**1 Products affected**

Product Change Notification					PCN DG11 Inlet gasket integred		
owner	creation date	release date	released by	change order	rev	page	D10-068-096
sariogar	20.09.2022	05.05.2023	sariogar	2024944	A	1 of 2

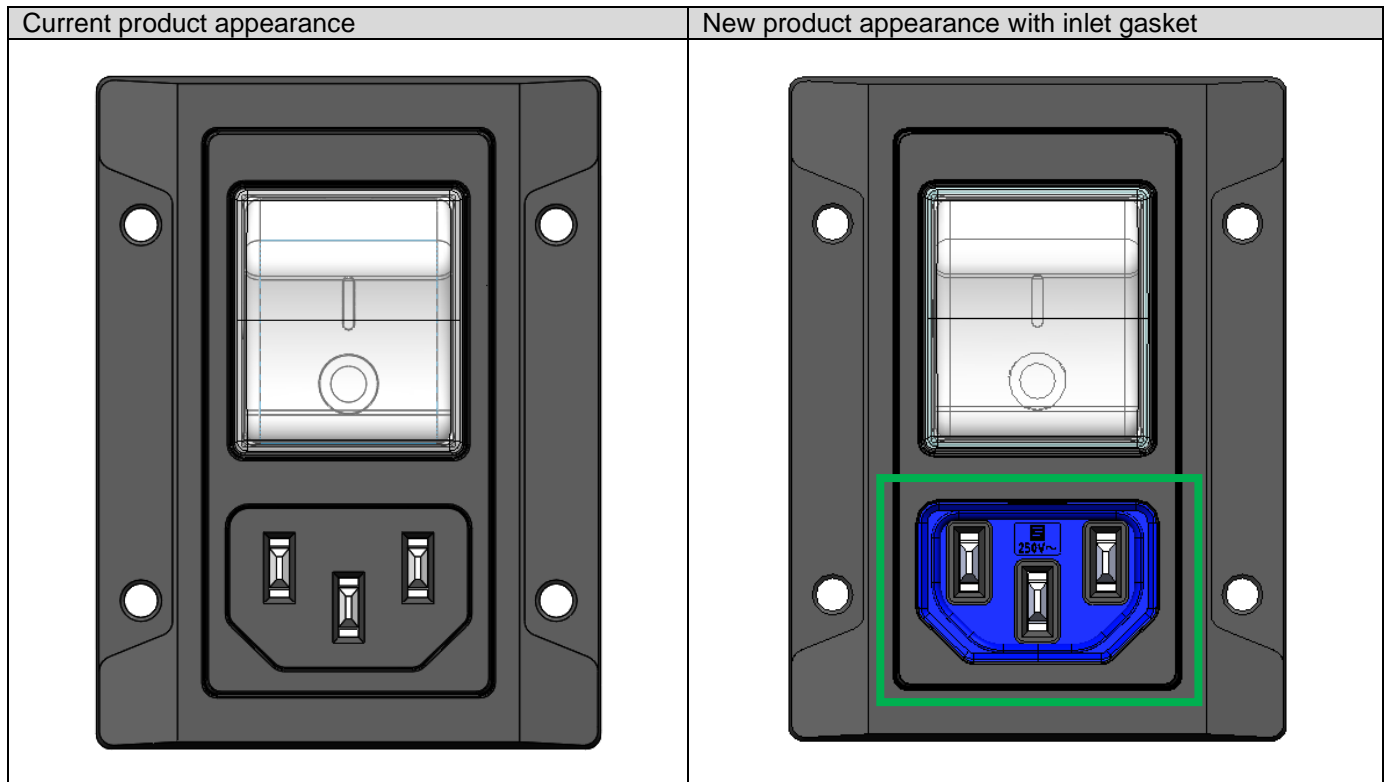
- Additional ingress protection against dust and/or liquids while connected for IP67 variants
- New inlet gasket for Ingress Protection of Power-connection
- Upgrade of Ingress Protection IP54 while connected with dedicated IP54 cordsets

- DG11, IP67 Variants towards housing fulfil new in addition IP54 against the power connection with dedicated IP54 cordsets
- This is done by assembling the blue Inlet Gasket as a standard
